SPEN observations on the Mona Offshore Wind Farm Project

Impacts on SPEN network and measures to control these in the DCO

Ffynhonnau Farm

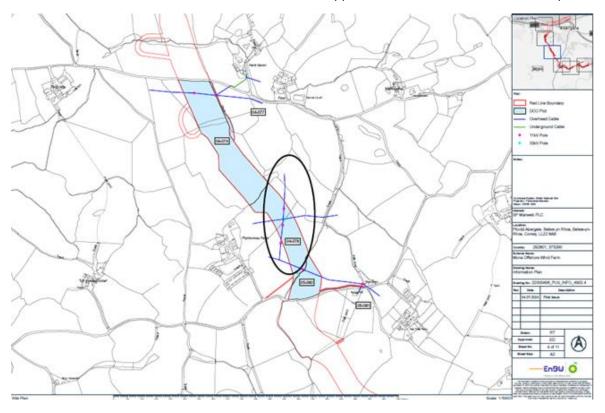
At this location there are two overhead circuits and supports which limit cable installation options.

Bryn-tywydd

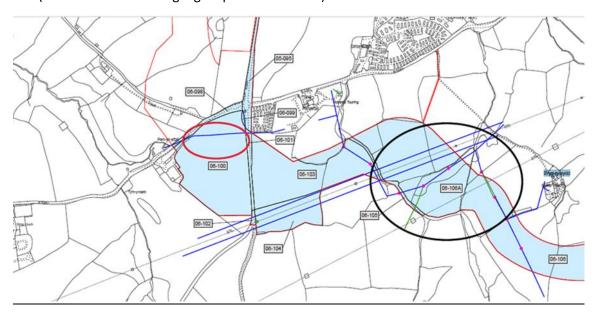
At this location, there are 11kV poles the movement of which is restricted by the 132kV overhead line (the red circled area highlights poles not shown).

Plas-newydd

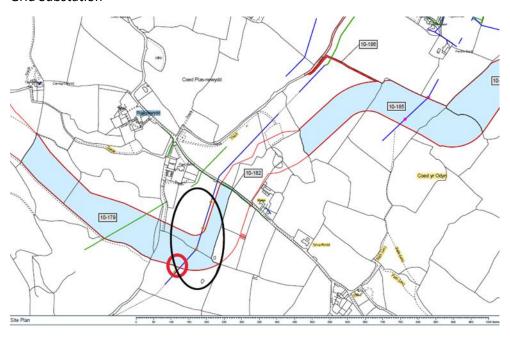
At this location, the 132kV circuit is a double wood pole line from a customer wind farm to St Asaph Grid Substation

Hendy Farm

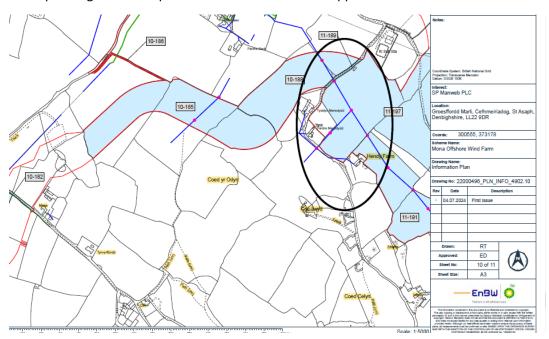
At this location, there are a number of wood poles to avoid and in addition, the area leading into the substation is a proposed landscaping area, the design of which needs to be considered in detail as some planting is not compatible with the SP Manweb apparatus.

In relation to the proposed landscaping under SPEN assets, SPEN requires to be consulted on the further detail and suggests Requirement 7 is amended as follows:

7.—(1) Work No. 22 must not be commenced until a landscape plan and associated work

programme has been submitted to and approved by the relevant planning authority following consultation with NRW and SP Energy Networks as appropriate.
